CHANGE ORDER FORM
Riggin Avenue Widening & Improvements Project

Change Order No.: <u>1</u>	City Project No.: <u>3010-72000/CP0398-999</u>
Submitted by: <u>Diego Corvera</u>	Federal No.: <u>N/A</u>
Date Submitted: <u>December 8, 2025</u>	Purchase Order No.: <u>PO4217</u>
Committee Review Date: <u>December 10, 2025</u>	Package No. of Pages: <u>5</u>

PCO 04.1 - Water System Material Change

NEW BUSINESS PROJECT
RIGGIN WIDENING
FROM KELSEY ST TO SHIRK ST

VIS-6641 R1

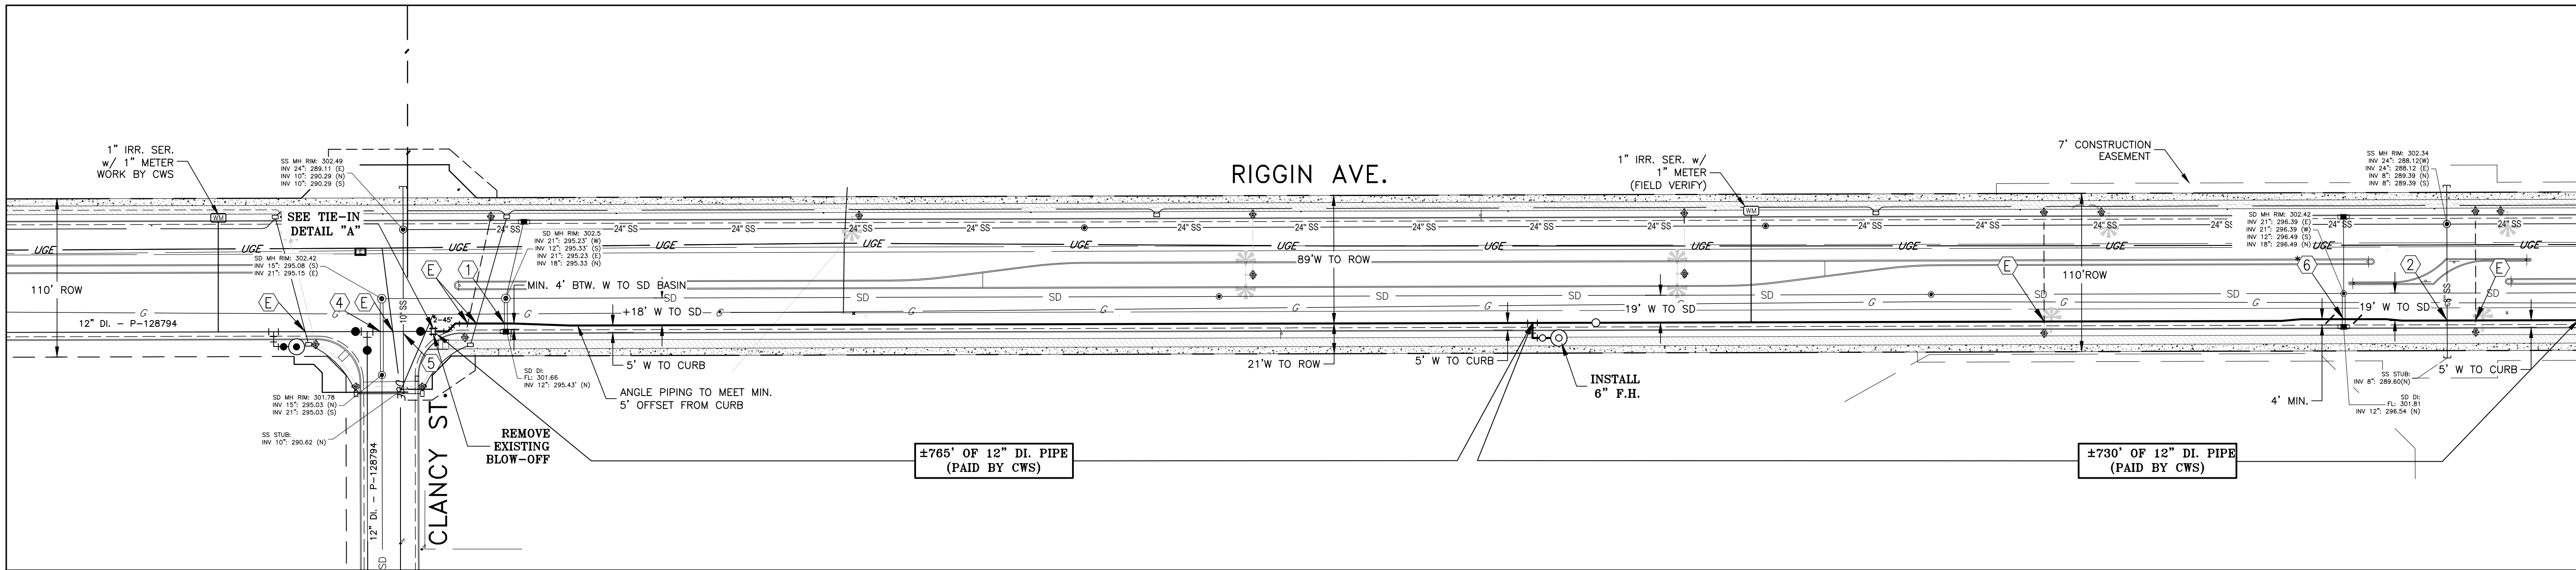
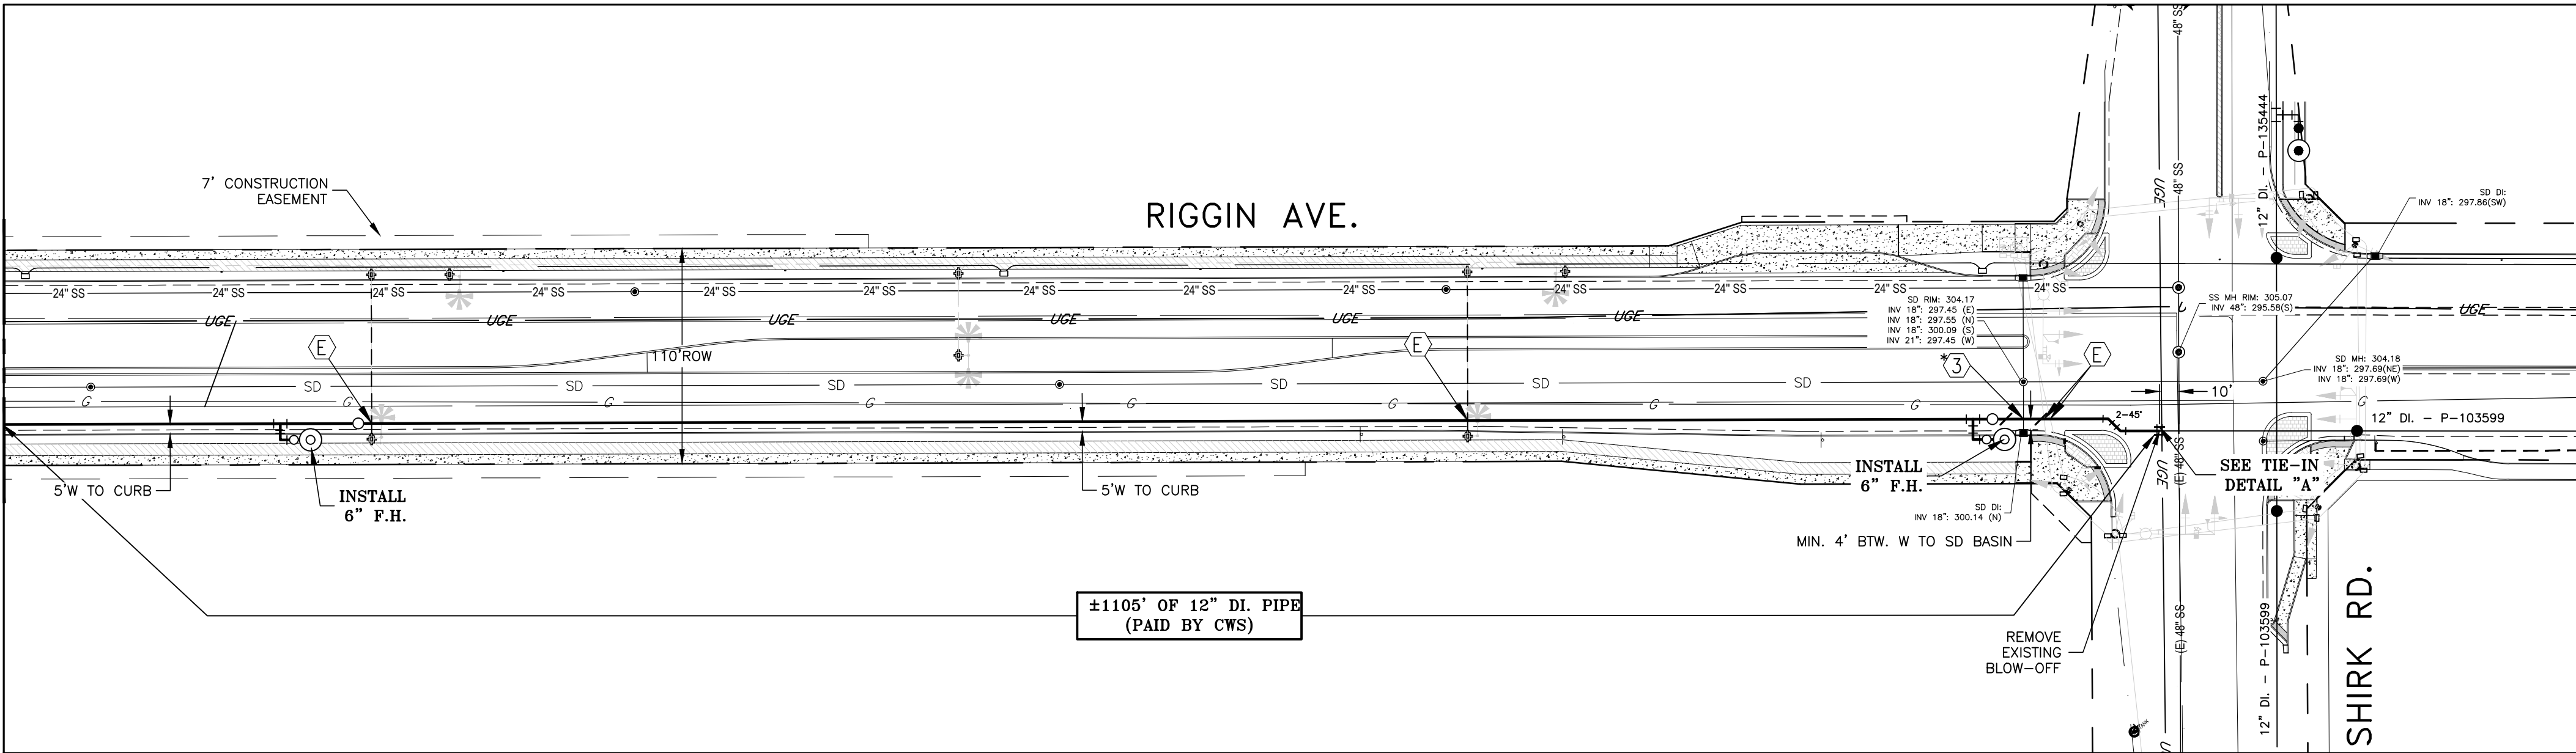
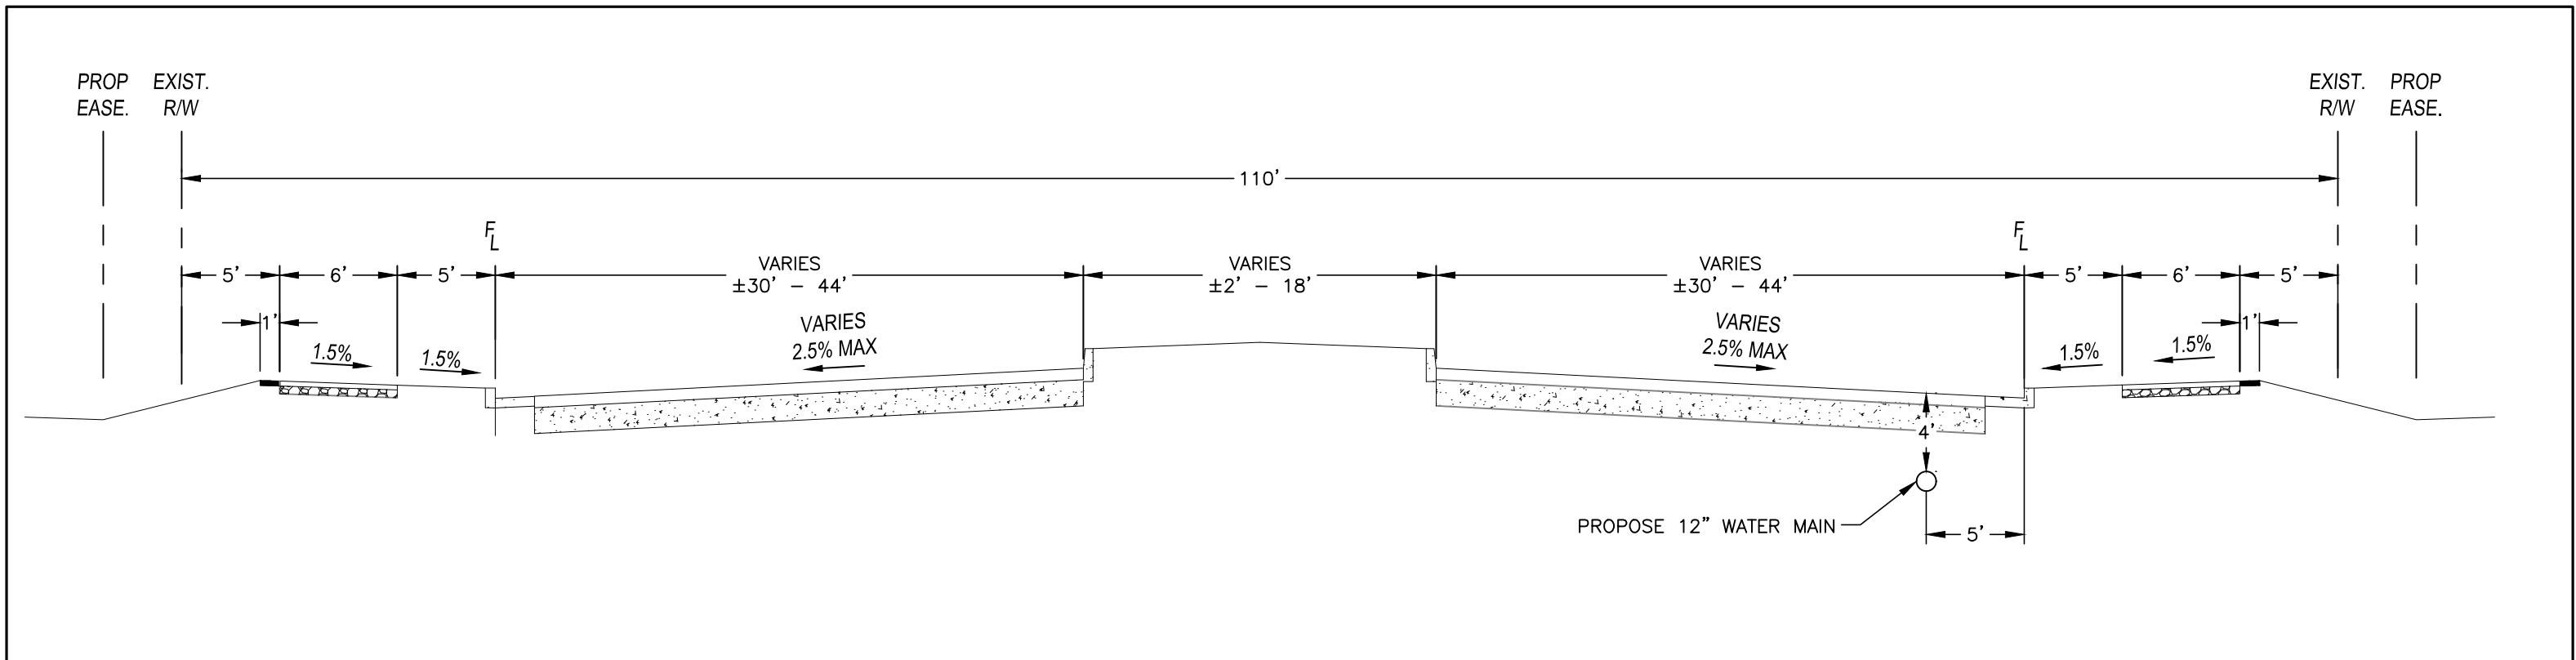
Contractor to install 2,583 LF of 12" ductile iron water pipe, 3 EA fire hydrants, 3 EA 12" gate valves, 1 EA irrigation service, and 2 EA CL&C offsets as shown on the revised plan sheets dated 6/6/2025, included as sheets 3 through 5 of this Contract Change Order. The bid set of plans called for 2,583 LF of 12" water pipe and 3 EA fire hydrants. Per Calwater specification, C900 PVC pipe and ductile iron pipe are both allowed. After bid opening, final Calwater plans were provided, pages 3 through 5 of this Contract Change Order, that specified the requirement of ductile iron pipe and the addition of 3 EA gate valves, 1 EA irrigation service, and 2 EA CL&C offsets. This change order provides payment for the pipe material change and the addition of the gate valves, irrigation service, and CL&C offsets. All work shall be in accordance with Contract documents.

This cost proposal is to address the plan revision from California Water Service (CWS) received 7/31/25 changing the pipe material from PVC to Ductile Iron and adds (3) 12" gate valves, (1) irrigation service and (2) CL&C offsets.
